Public Works Department – Engineering Division

ADDENDUM NO. 3

PROJECT 5067 WTP FILTER IMPROVEMENTS AND HYPOCHLORITE CONVERSION

DWG. NO.
A100

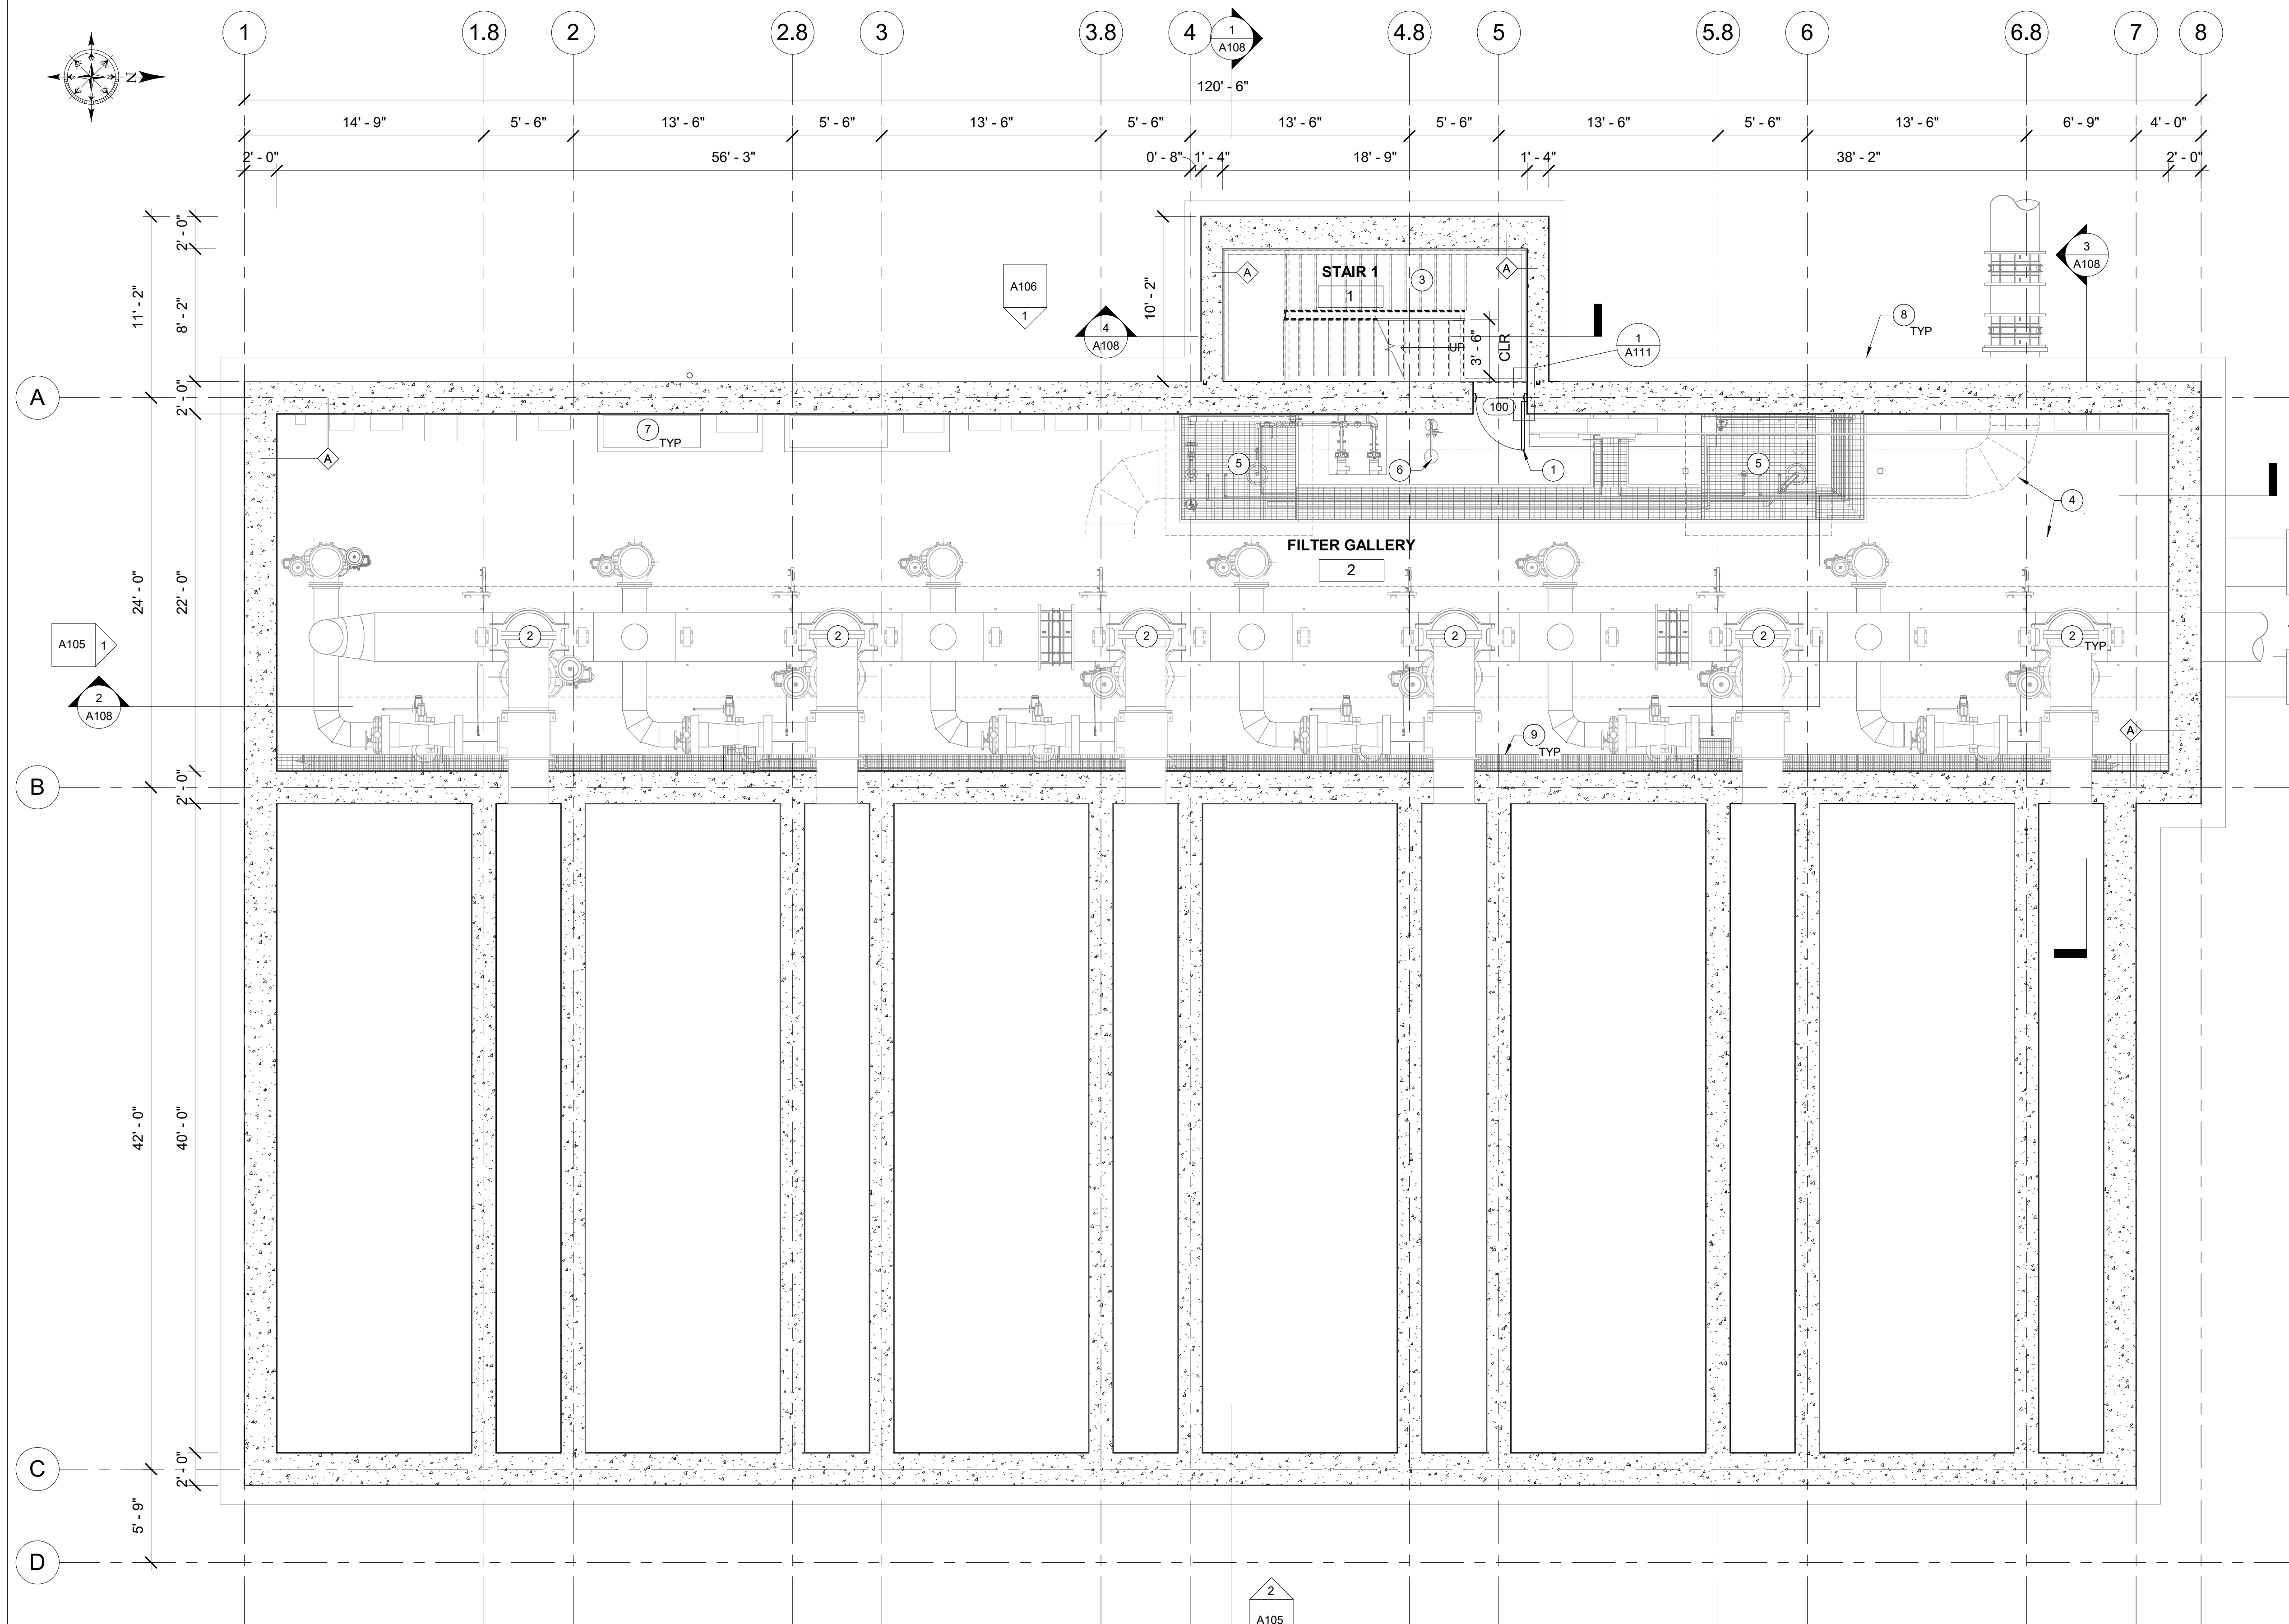
1. See attached revised Architectural Drawings showing double doors on the South Side of the building and between the Blower Room and the Electrical Room. Delete the hatches and the roof penetrations for the hatches shown on Drawing A107. Please note that the addition of these double doors and the deletion of the roof penetrations will be updated in the Conformed Documents for the other drawings in these Bid Documents.

20. Wall type D/A100 depicts a 3-1/2" metal stud with 5/8" gypboard attached on each side of metal stud. Detail 1/A113 depicts wall type D as having wood crush blocks on exterior side of metal stud and ridged insulation, then the gypboard. Please clarify.
